LiDAR Quality Assessment Report

SD_MORiver-Dewberry_2016-Block-5

NGTOC
 2018-09-21
 Jessica Self

Vertical Accuracy Results:

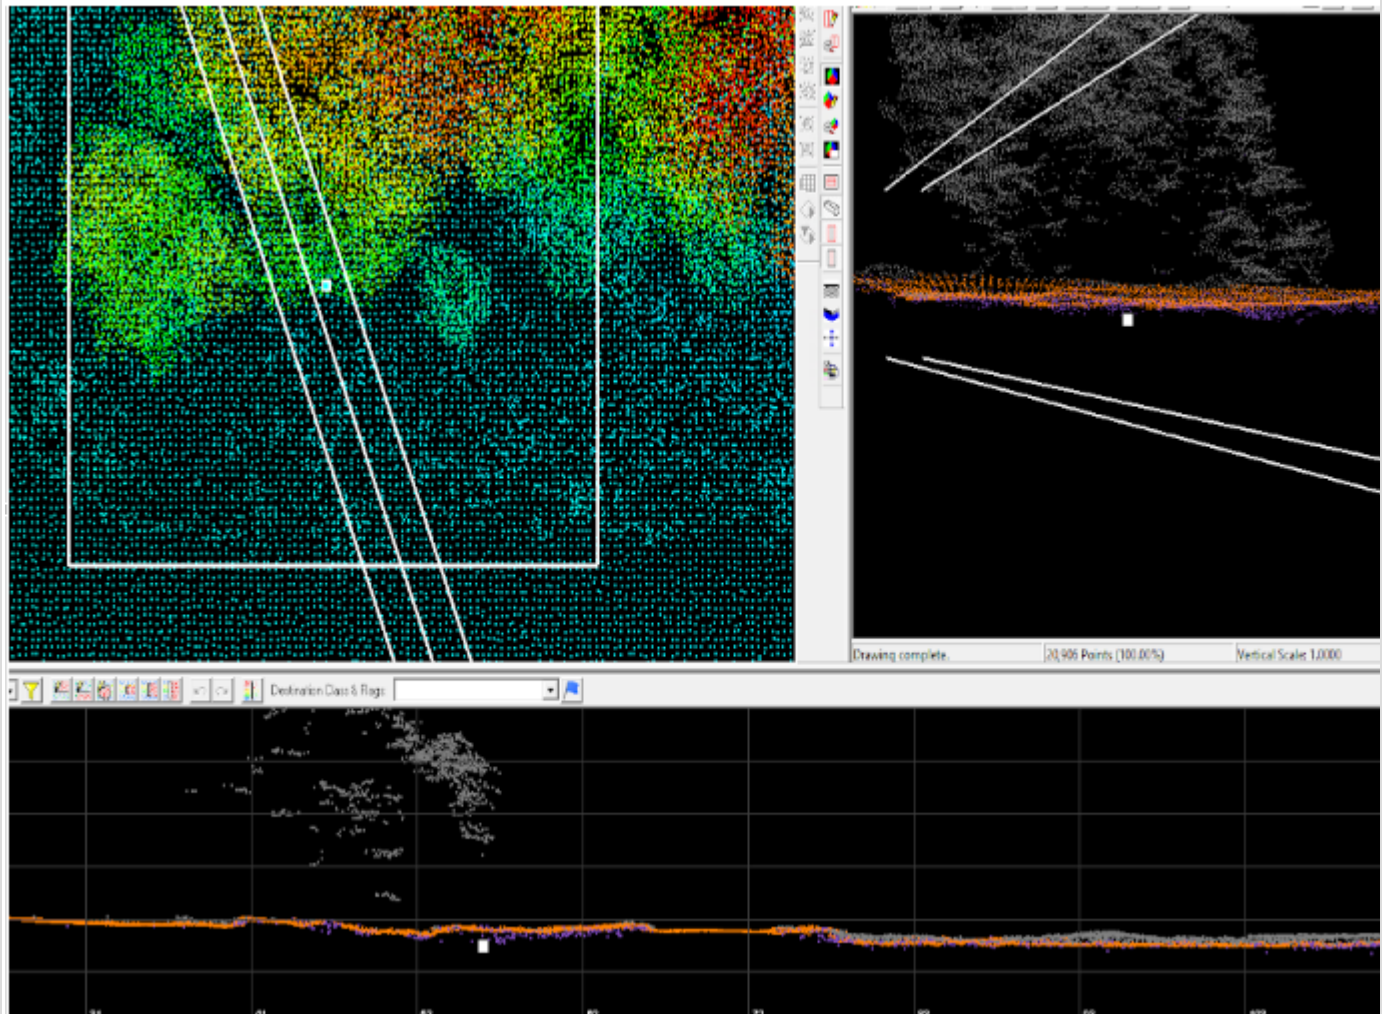
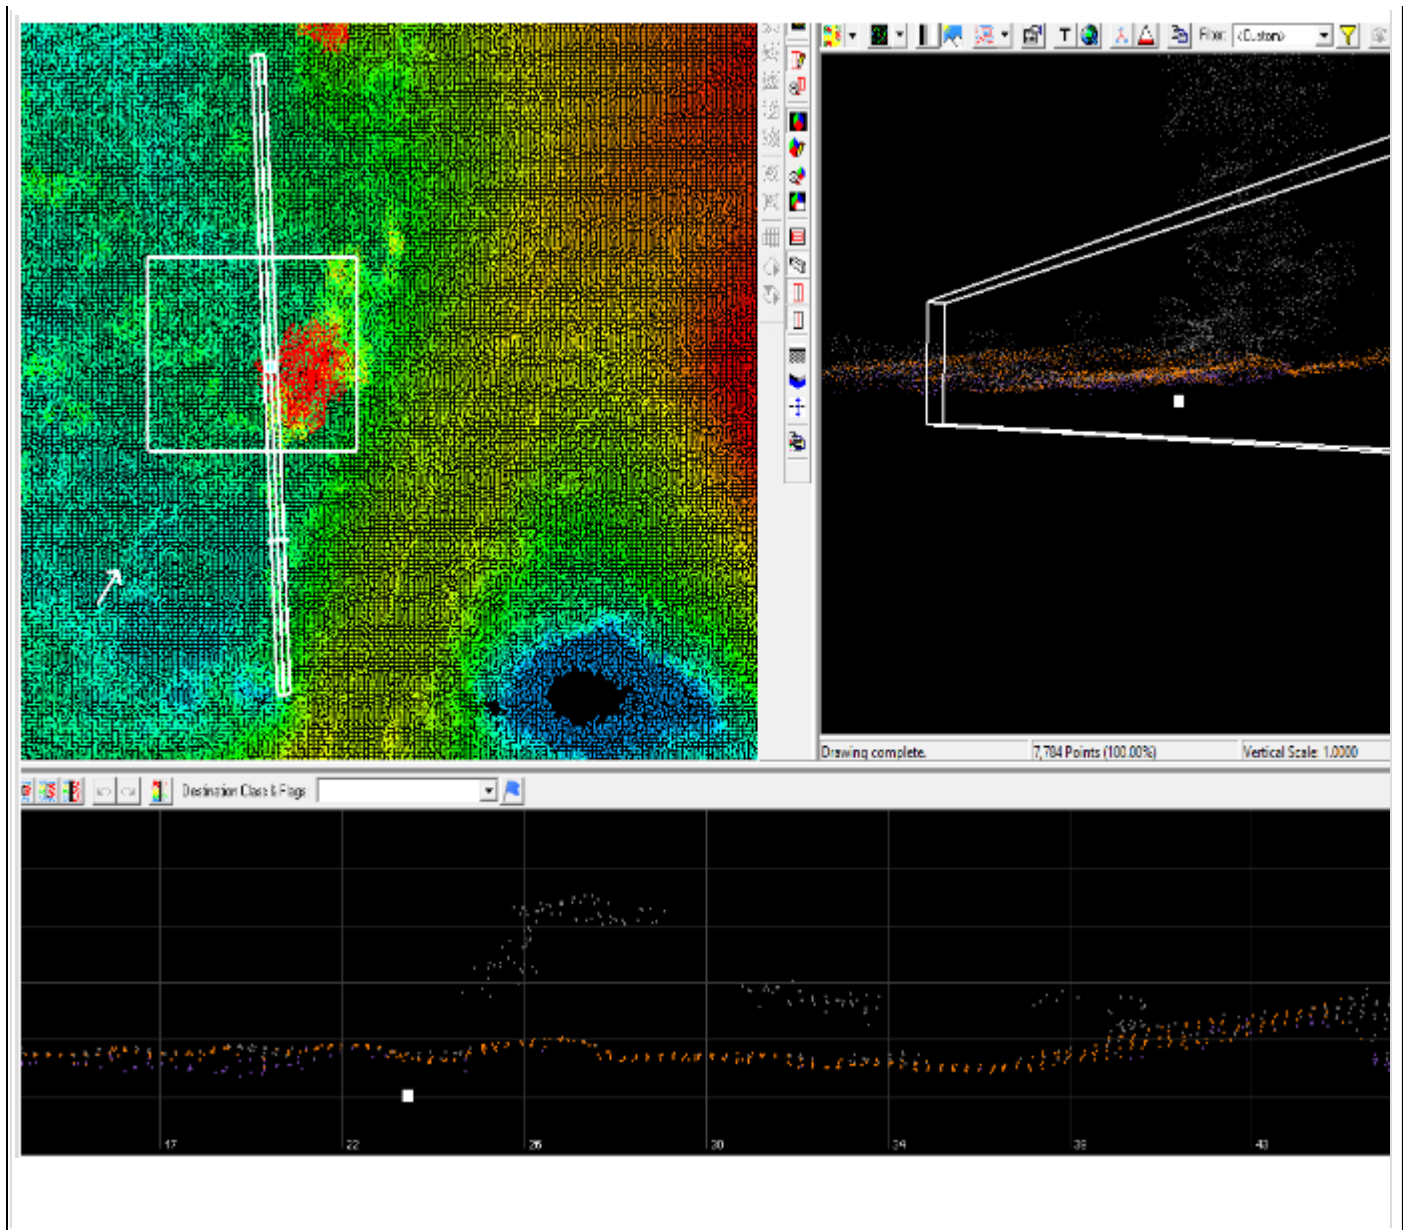
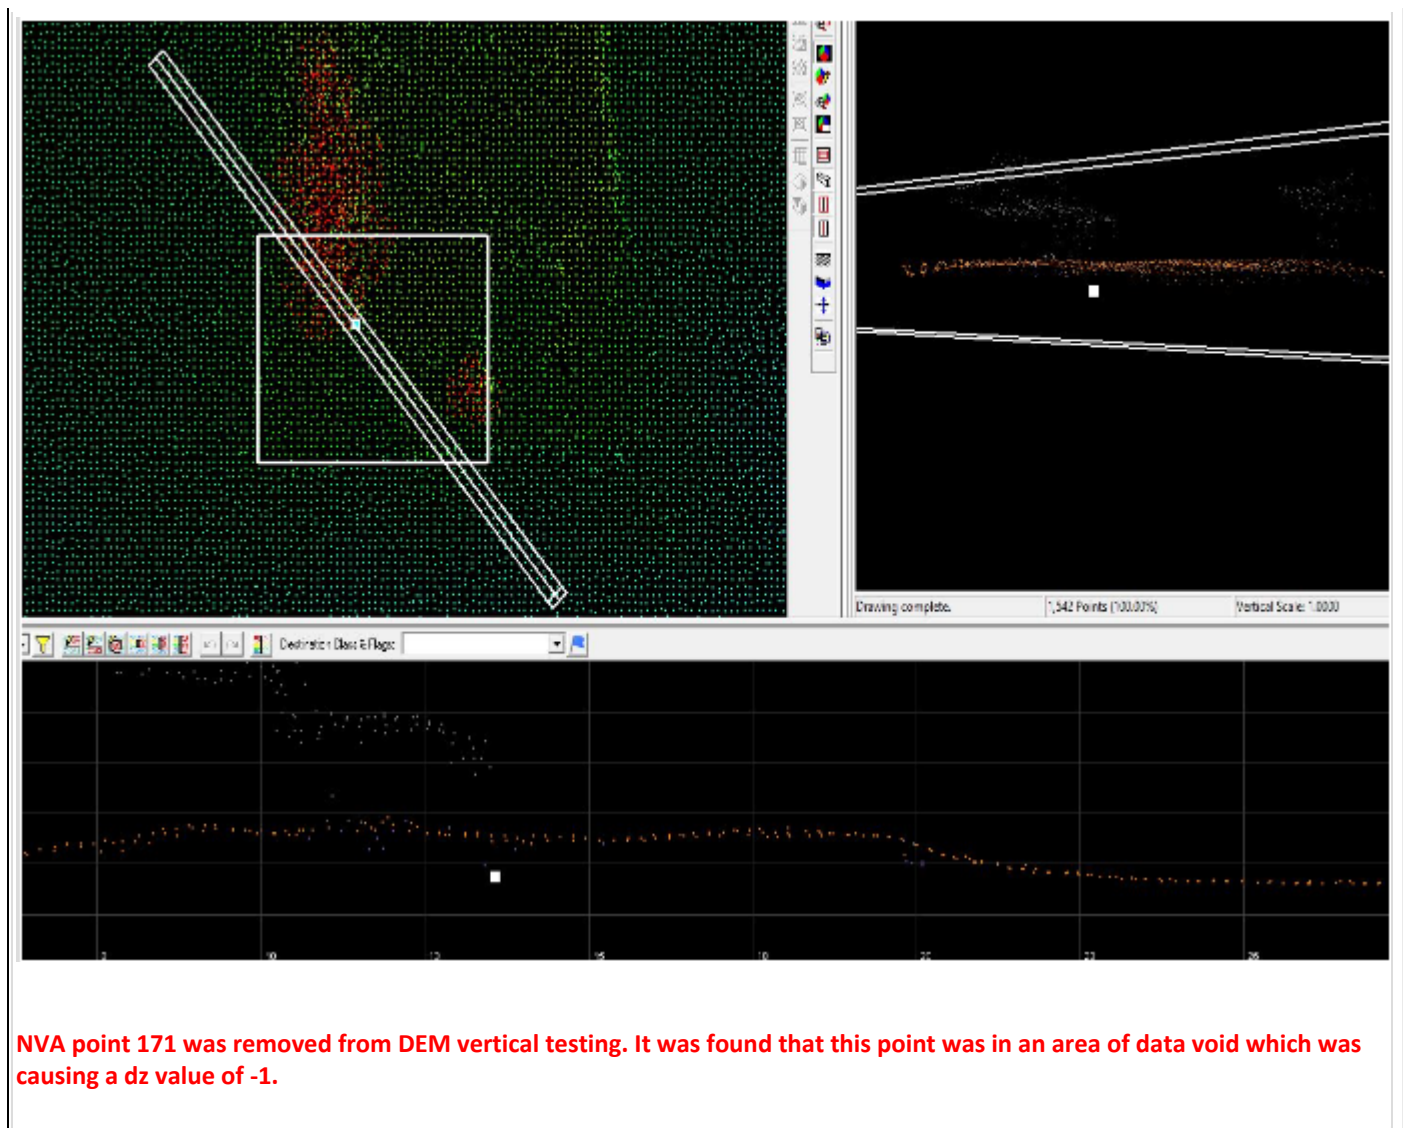
NVA point 171 was removed from DEM vertical testing. It was found that this point was in an area of data void which was causing a dz value of -1.

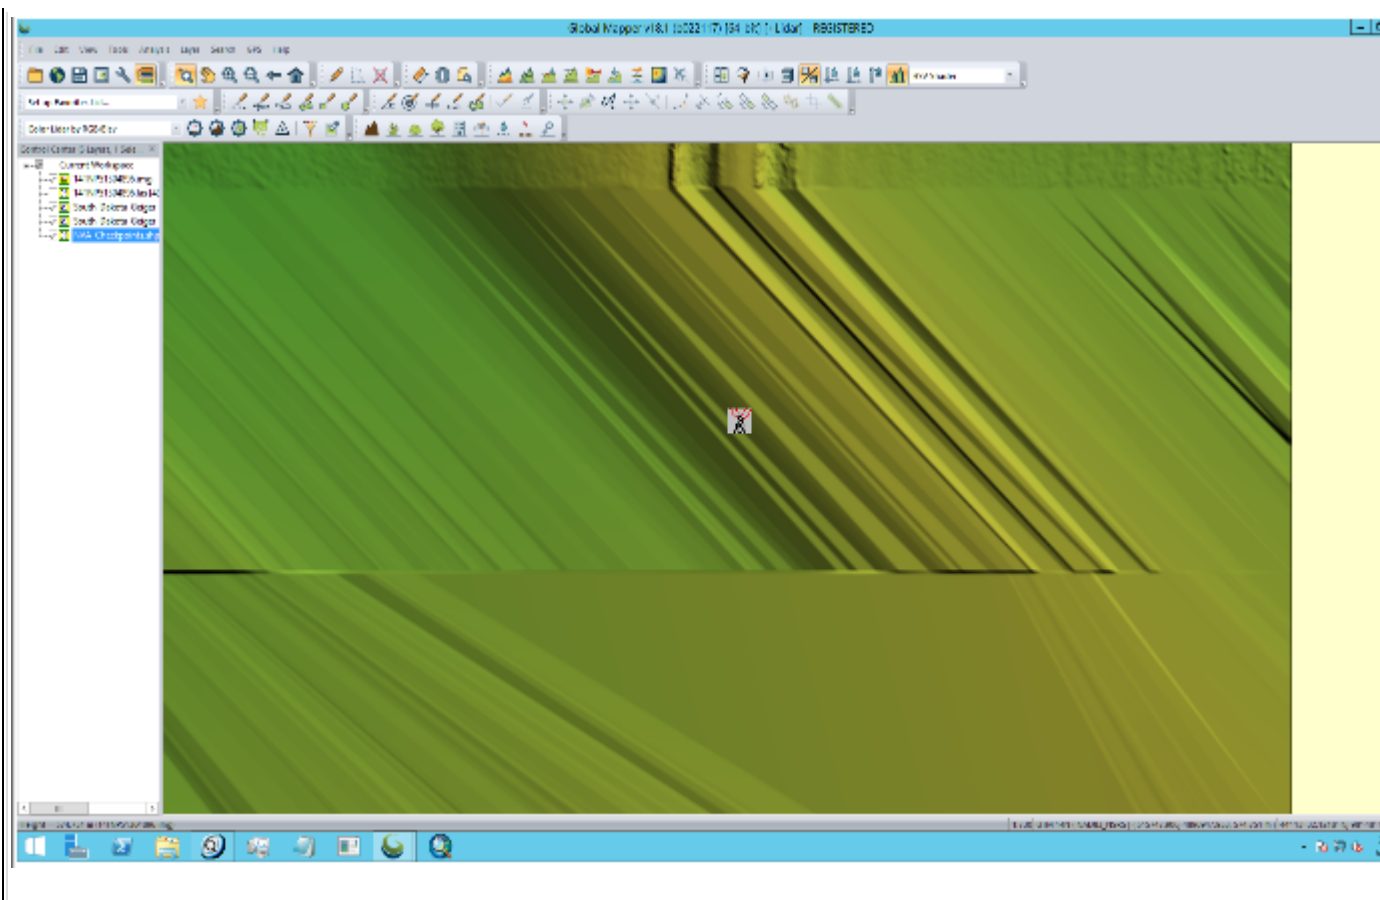
VVA testing failed to meet USGS specifications. Three of the worst points are pictured below, showing the checkpoint below the ground surface.

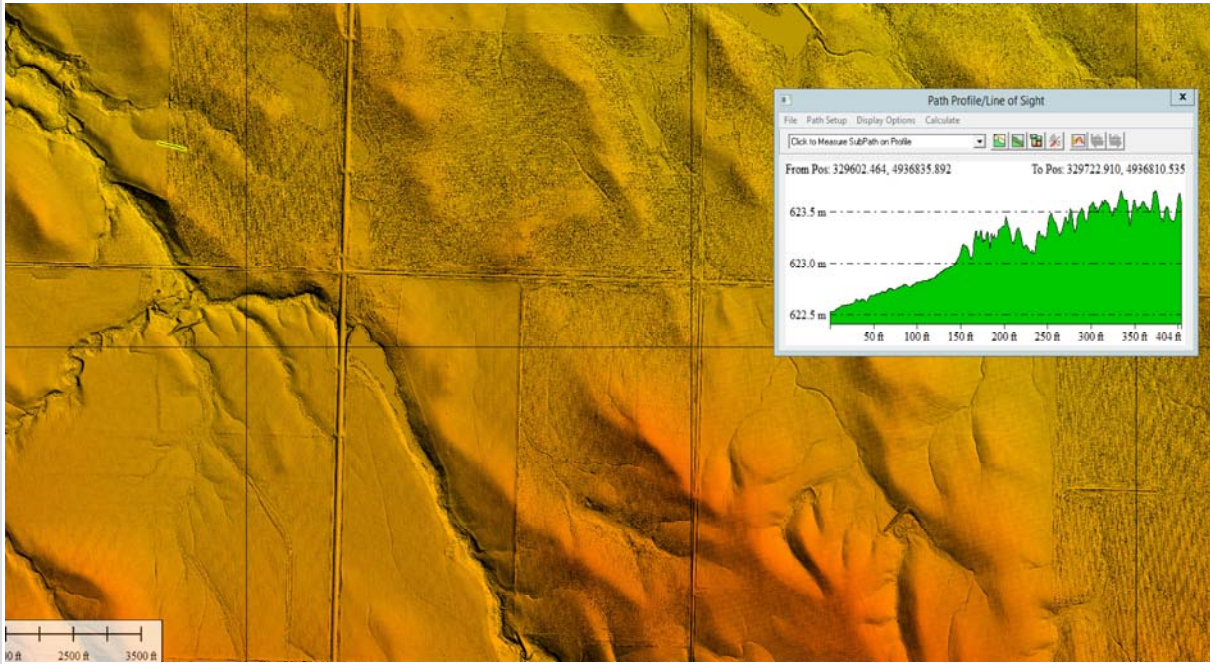
All through out block 5 there are areas of a possible classification issue: ground and low noise points in areas where there could be vegetation in fields.
